ADDENDUM NO. 4

May 6, 2025

This Addendum contains changes to the requirements of the Contract Documents and Specifications. Such changes are to be incorporated into the Construction Documents and shall apply to the work with the same meaning and force as if they had been included in the original document. Wherever this Addendum modifies a portion of a paragraph of the specifications or a portion of any Drawing, the remainder of the Paragraph or Drawing shall remain in force.

**RENOVATE 2ND - 5TH FLOOR
AT KING-SHAW HALL**

02 FLOOR PLAN - FOURTH FLOOR
SCALE: 1/8" = 1'-0"

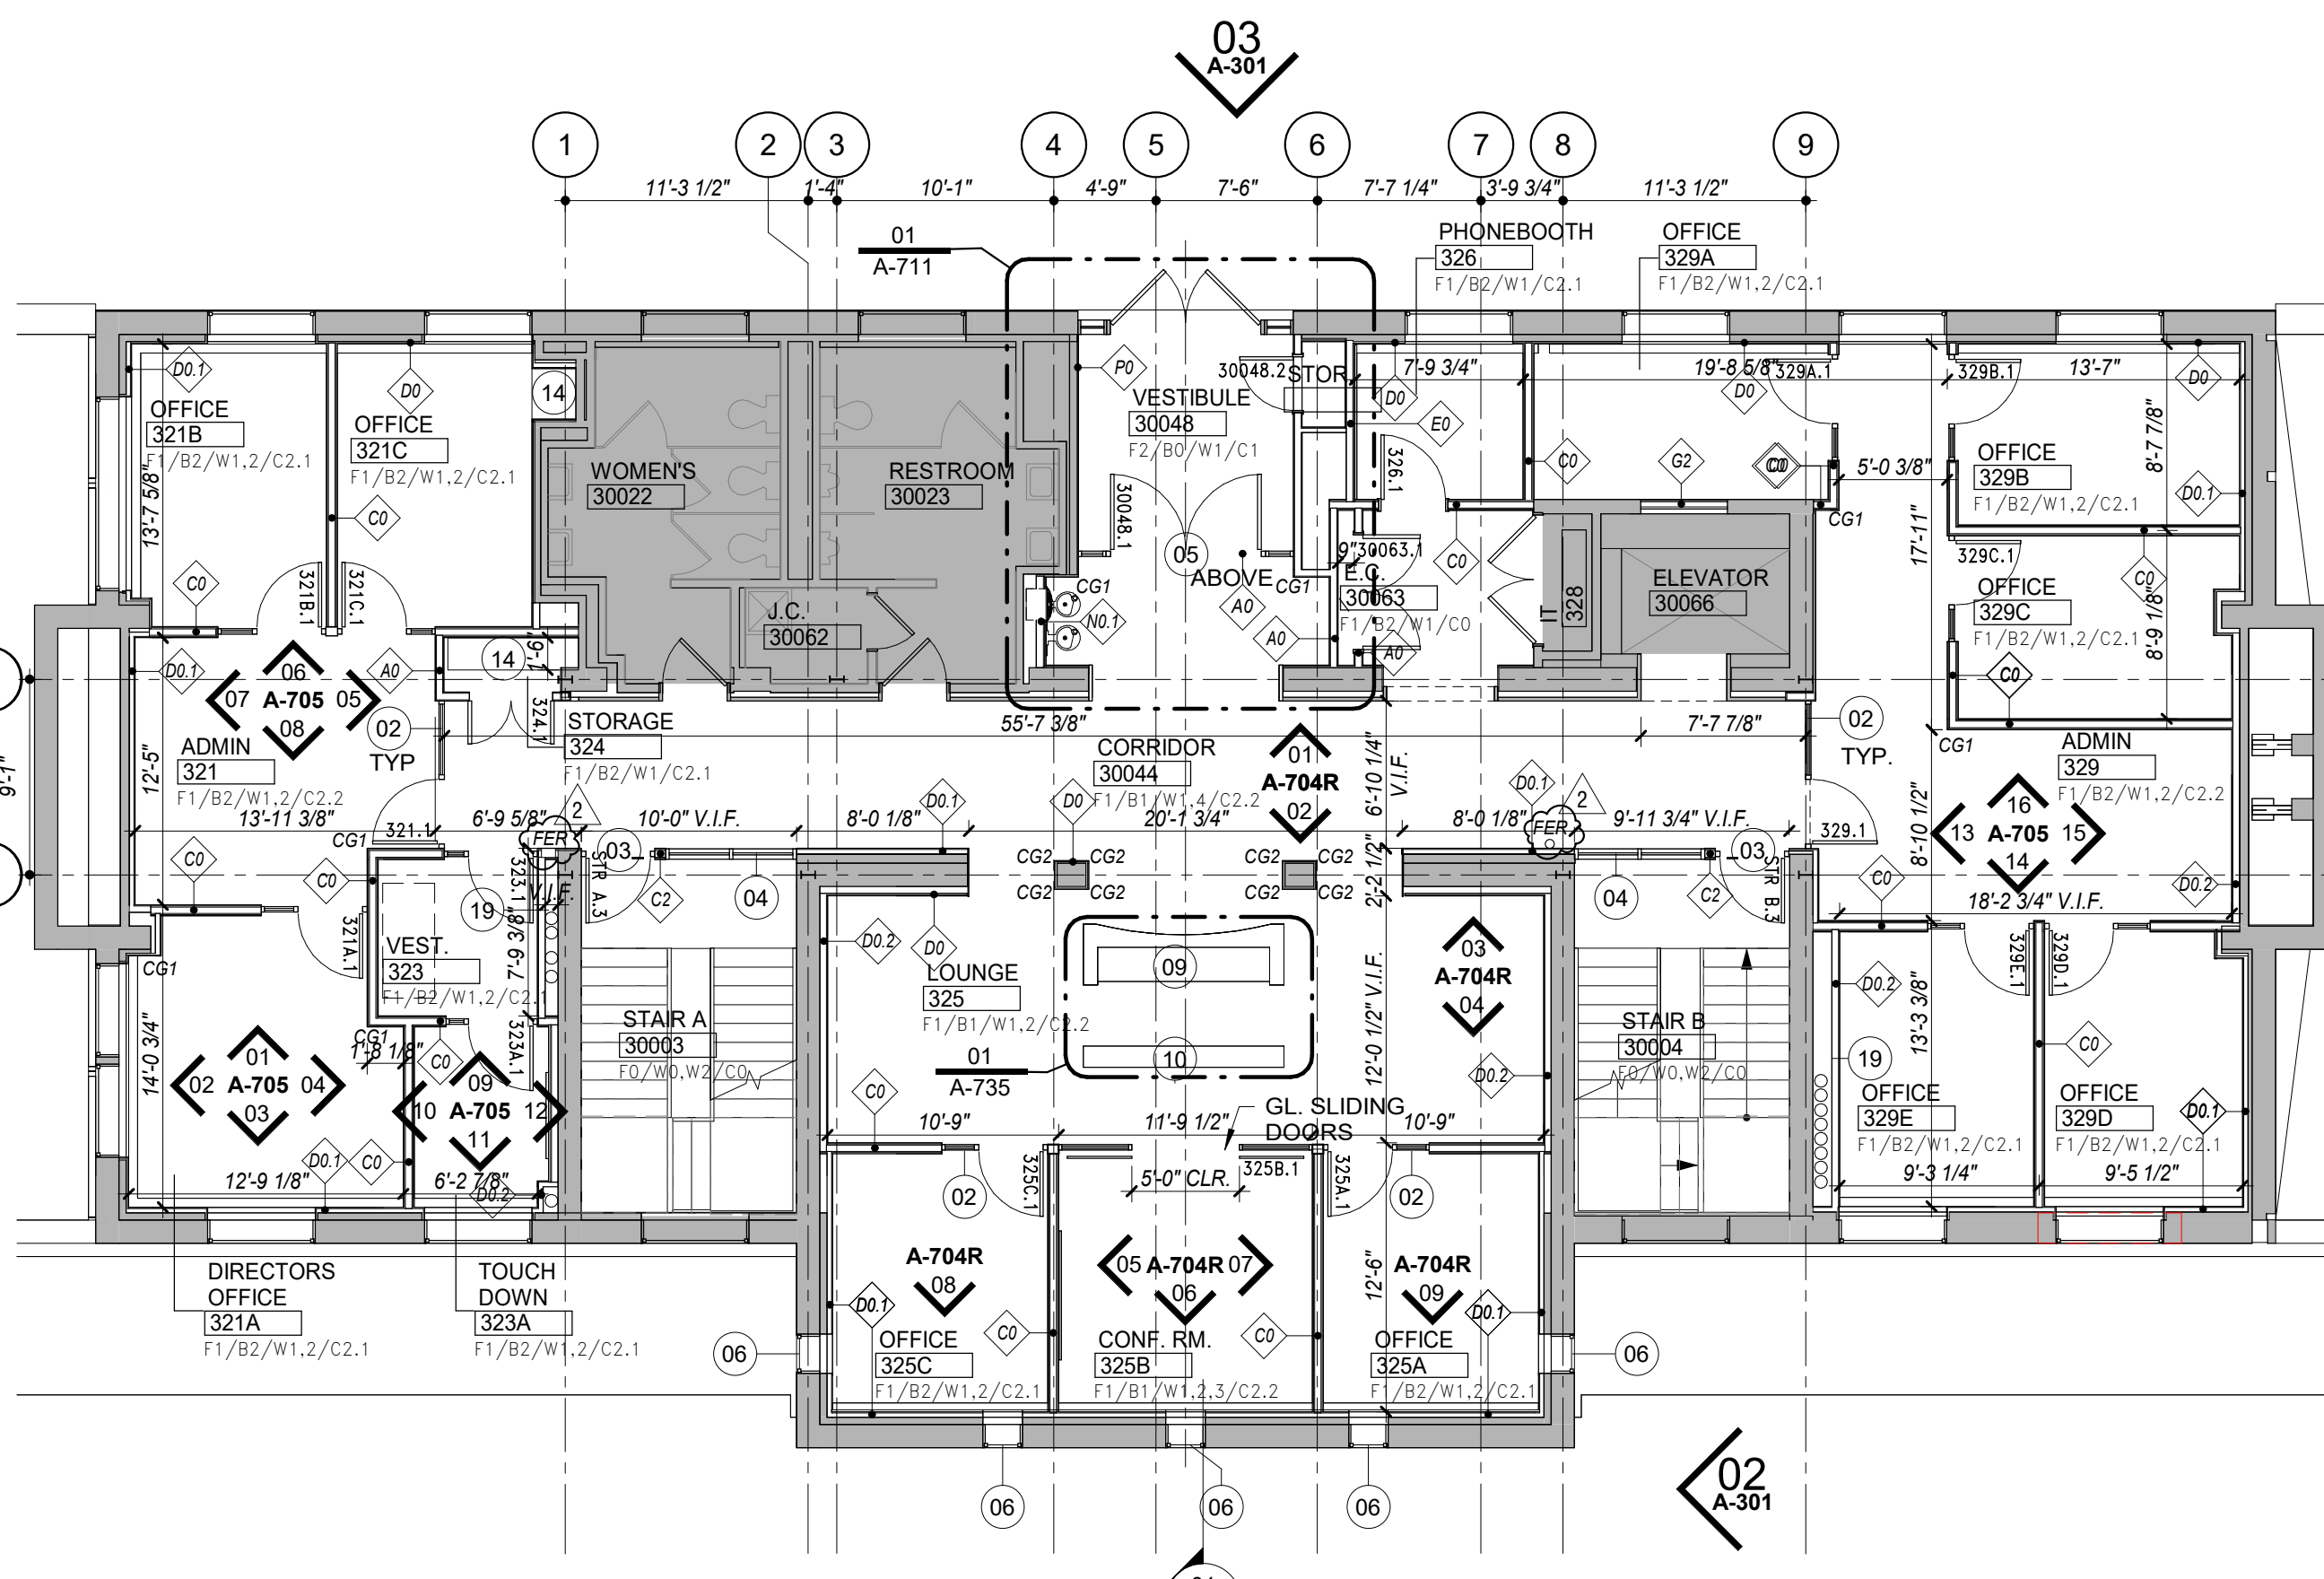
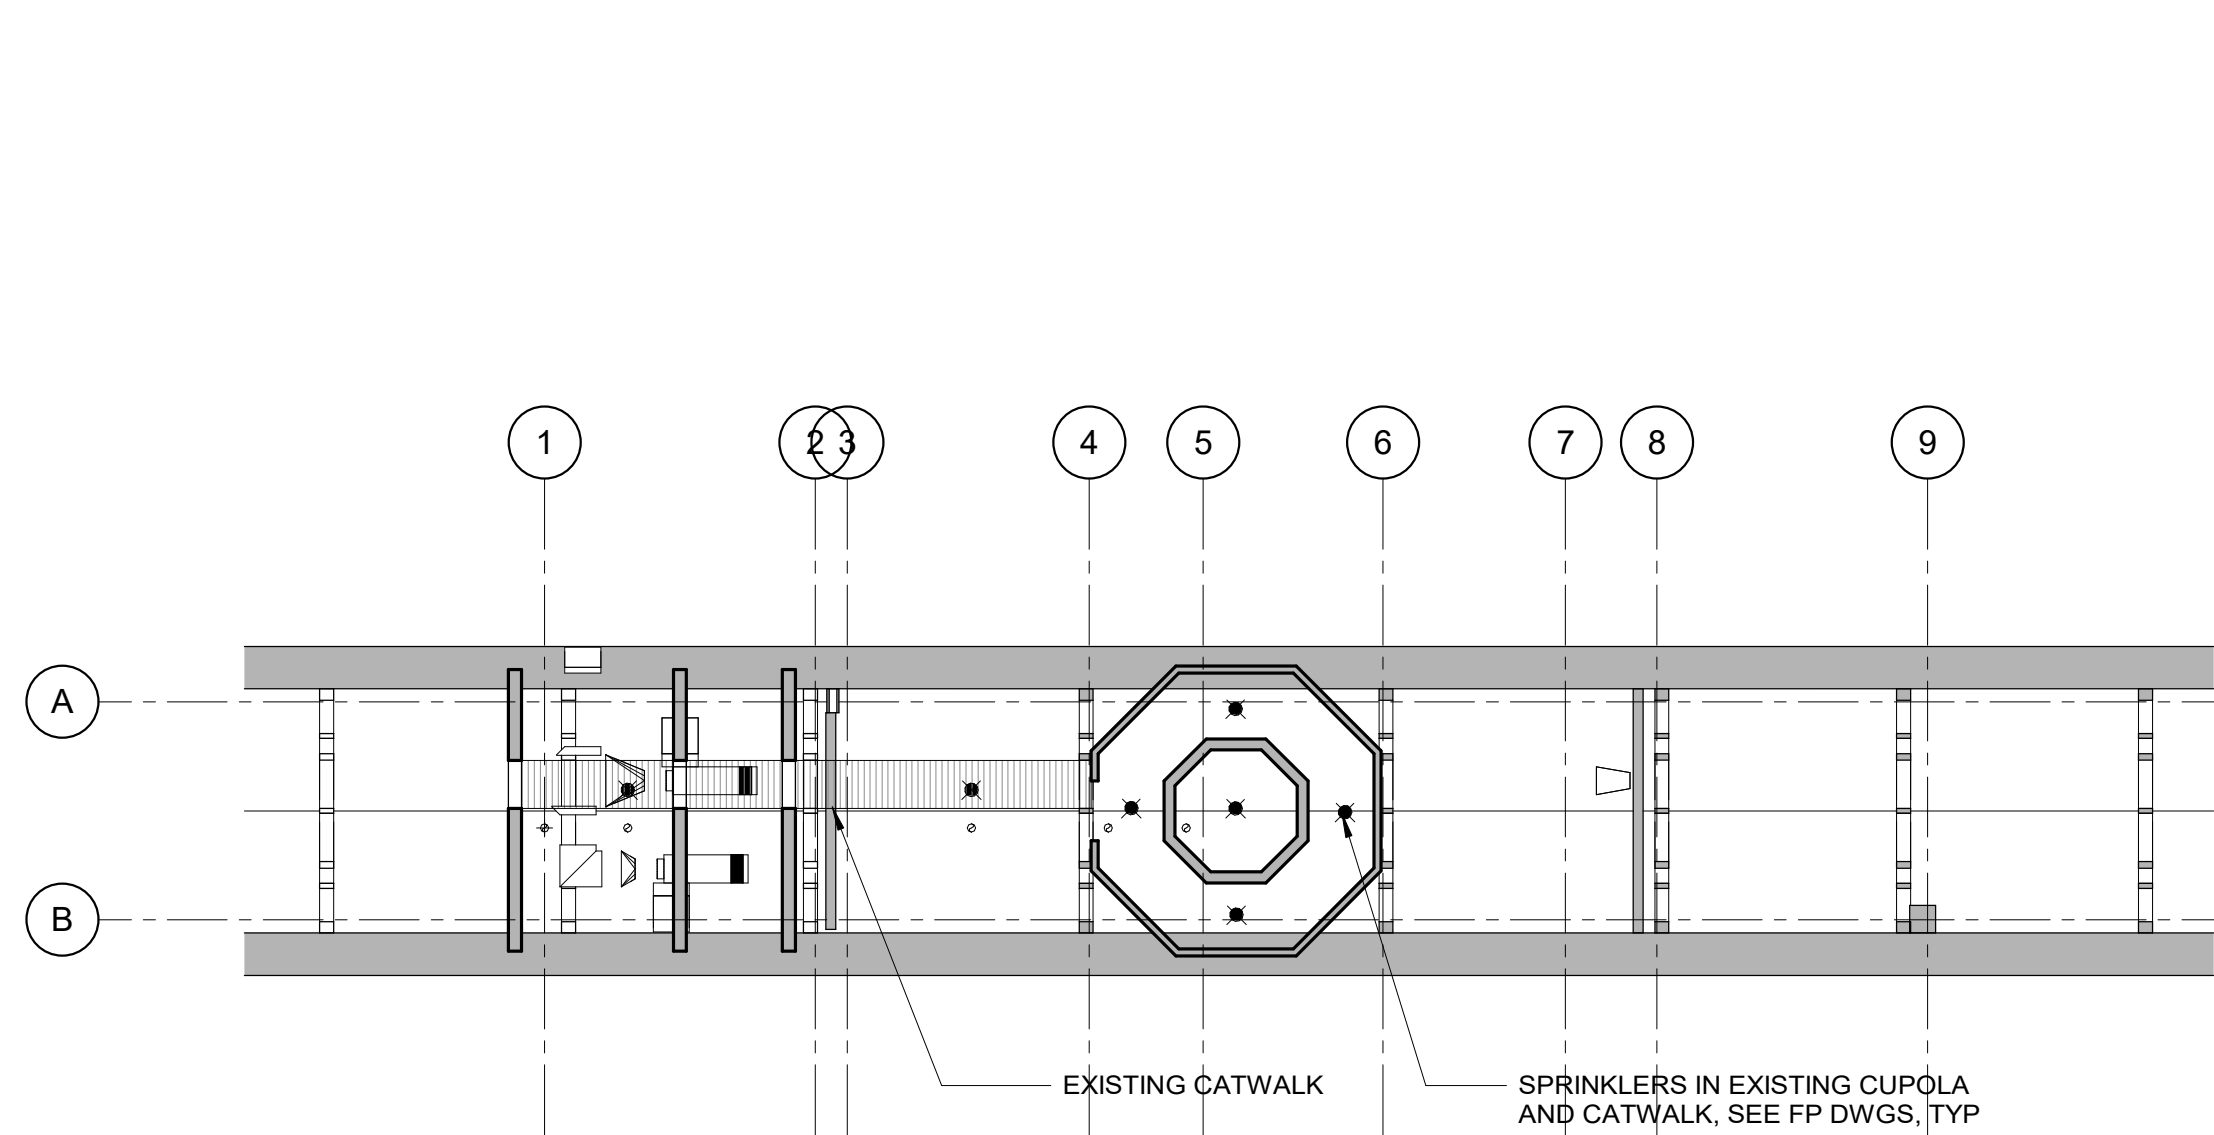
RFI/ Response Index	Page/ Dwg./Spec./Rep. Number	Section/ Paragraph/Topic	RFI	Design Team Response
26	104416	Fire Extinguisher Cabinets	Could not find any FEC shown on the drawings. There is a specification. Please clarify.	See Addendum No. 4 and revised Floor Plans locating FECs.
27	A-750	Signage	Drawing A-750 calls for vinyl signage at details 2, 3 and 5. Please update specification 101400 Signage with information regarding the vinyl signage. Also, these are called out at various interior elevations but the notes tell us to reference A-750. Sometimes it is quite clear what sign is desired but other times it is not. Can the interior elevation notes be updated to add which specific detail on A-750? This will help our signage vendors to provide the most accurate pricing possible.	Signage scope to be confirmed with Owner. See notes at detail 05 on Drawing A-750 for current scope information.
28	A-740	OFCI Items	Please reference A-740. The finish schedule calls for the Composite Paneling that is specified in section 068300 as OFCI. The specification does not indicate that this product is OFCI. Please clarify who is to be providing this product. Same question for items UF1 & UF2. All of the fabric items within specification 098413 Acoustic Panel Fabric are listed as OFCI as well. Please confirm who is to be providing these products.	Composite Paneling, UF1, UF2, and acoustic panel fabrics are Owner-Furnished, Contractor-Installed.
